Title: Advisory Committee on Reactor Safeguards
ESP Ad Hoc Subcommittee Meeting

Date: Wednesday, March 2, 2005

6 MEETING OF THE AD HOC SUBCOMMITTEE

7 ON EARLY SITE PERMITS

SSE vs RG 1.60

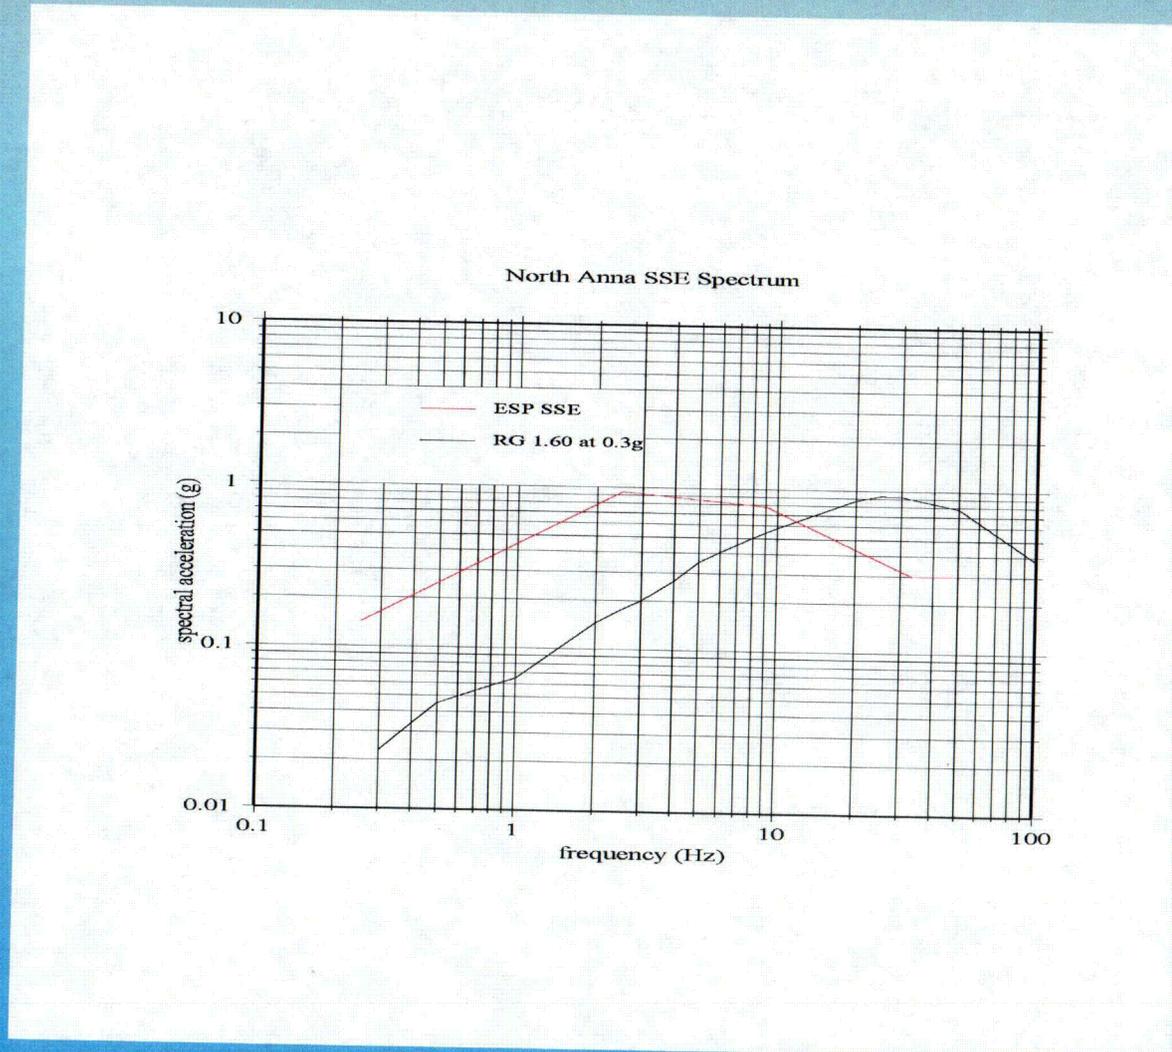
18 DR. APOSTOLAKIS: So how does this figure
19 -- how am I to read this figure? I mean the
20 independent variable is the frequency? So that if I
21 go in with a frequency of 10 hertz --

- Because North Anna is a rock site, site SSE exceeds design SSE at high frequencies for designs certified to date
- COL applicant would need to resolve disparity if one exists (dependent on design selected)
- See SSE vs. RG 1.60 diagram

8 Dominion chose to use an SSE spectrum that
9 falls on top of their performance-based spectrum. The
10 staff accepts or plans to accept that based on the
11 fact that it is conservative with respect to the 5
12 times 10 to the minus 5th low and high frequency
13 curves.
